Design Review Committee Meeting Agenda

April 15, 2019

UCSB Classroom Building

Design Review Committee

BUILDING FORM: TERRACE FORM STUDIES

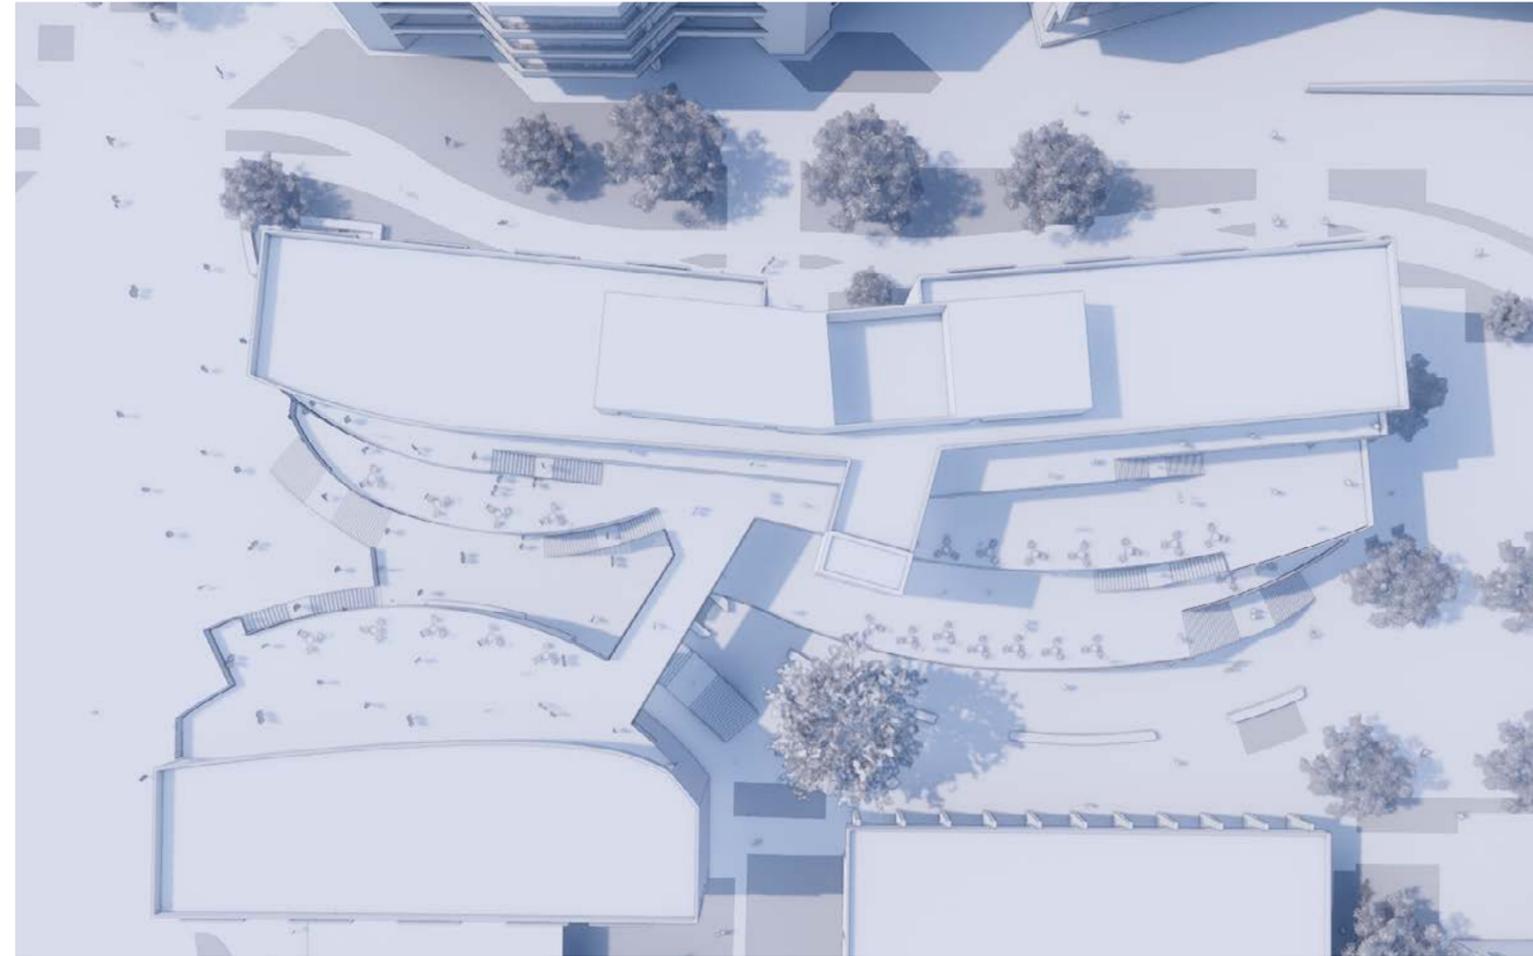
There is a possibility of creating a deep shaded 'canyon' on the north elevation.

The "street" design may create a "wind-tunnel" effect, aligning with the predominant winds from the WSW. A computer simulated wind analysis is underway to study this issue.

LANDSCAPE PLAN GRADE LEVEL EXPERIENCE

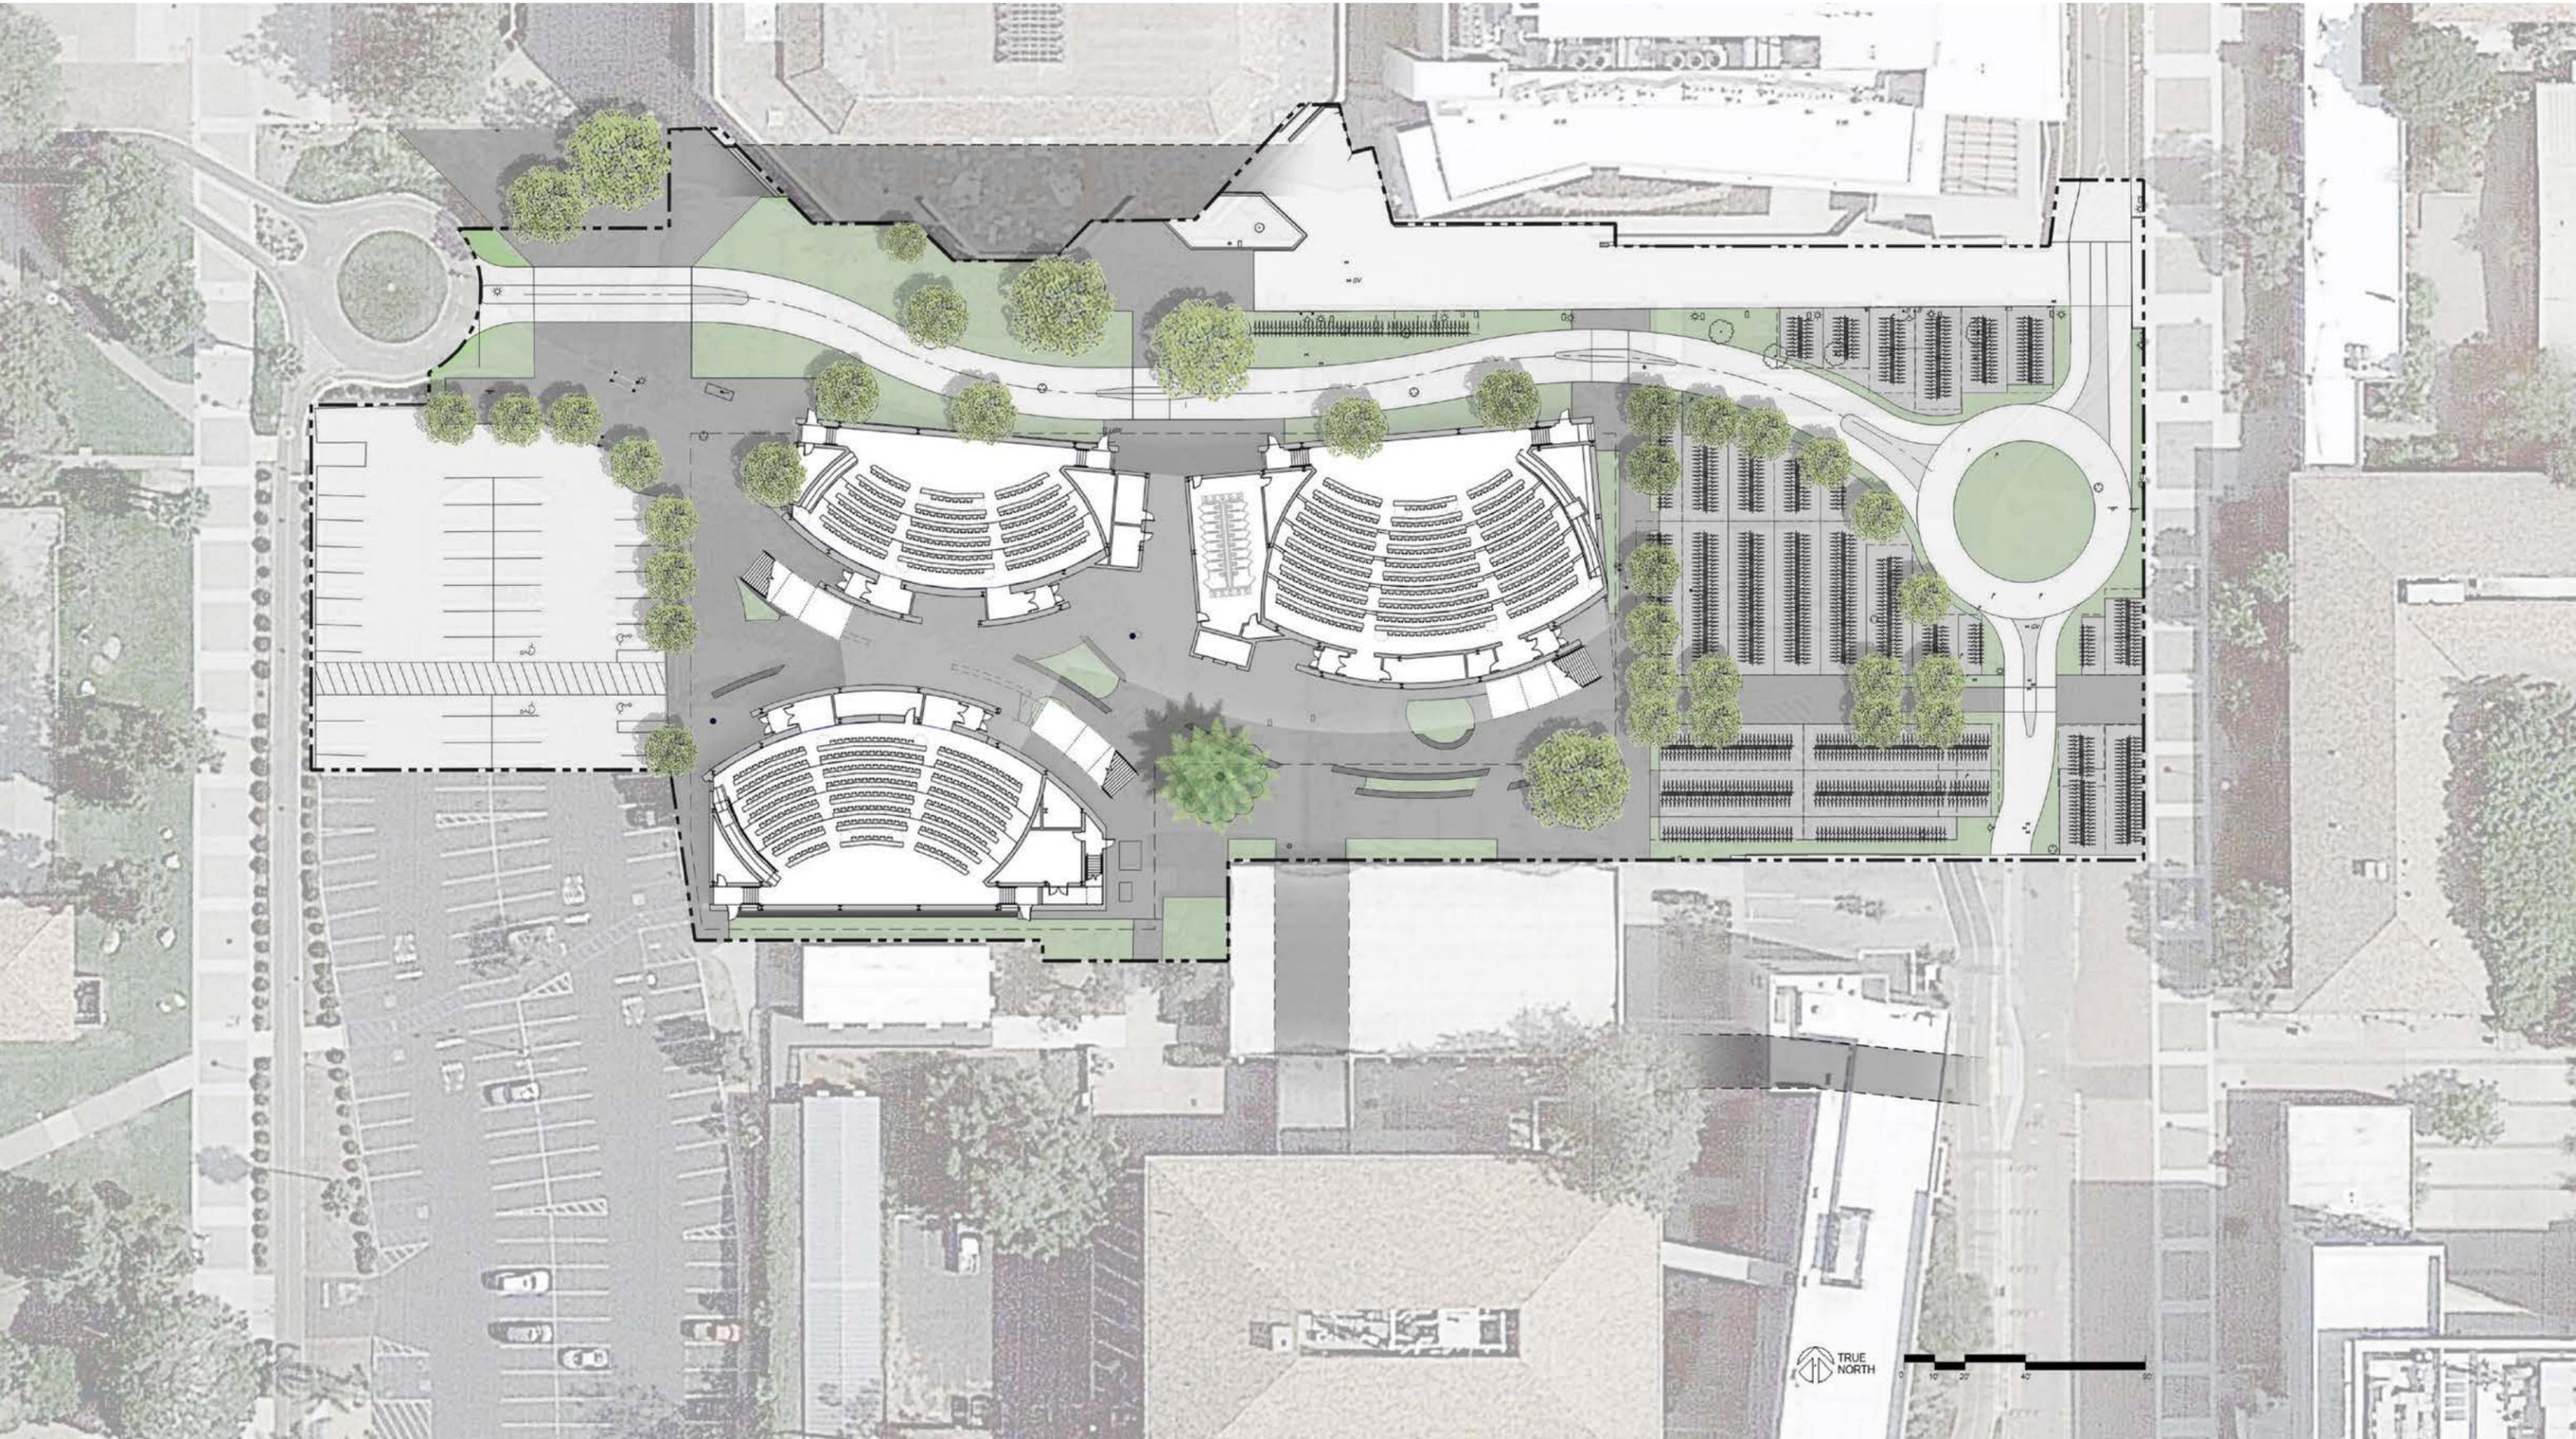
The relocated bikepath eliminates several mature Sycamore trees in the existing Library Bike Parking lot.

The Redwood tree may need to be removed for construction feasibility purposes.

CONCEPTUAL SITE PLAN

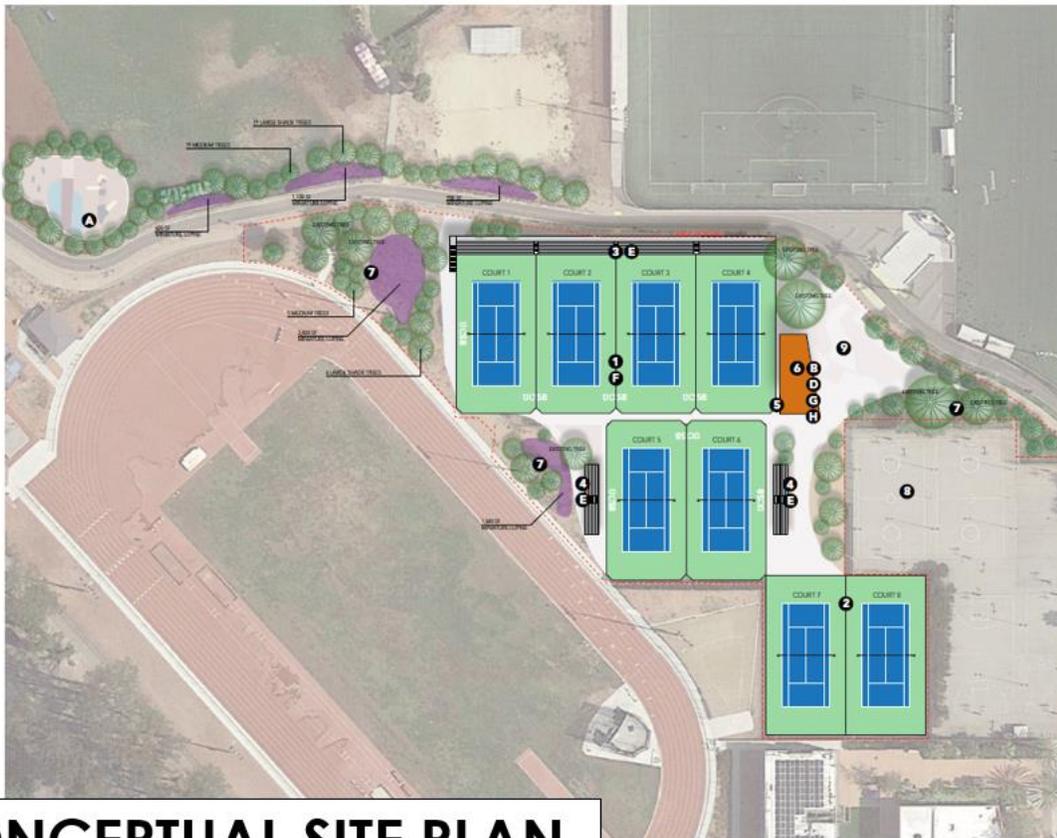
The underside of the northern bleachers and fence will alter views to the south from walkway and bikepath.

The project will remove 8 existing mature trees, including 4 native Oaks (*Quercus agrifolia*). These will be replaced at a 10-1 ratio, resulting in 44 trees being planted offsite.
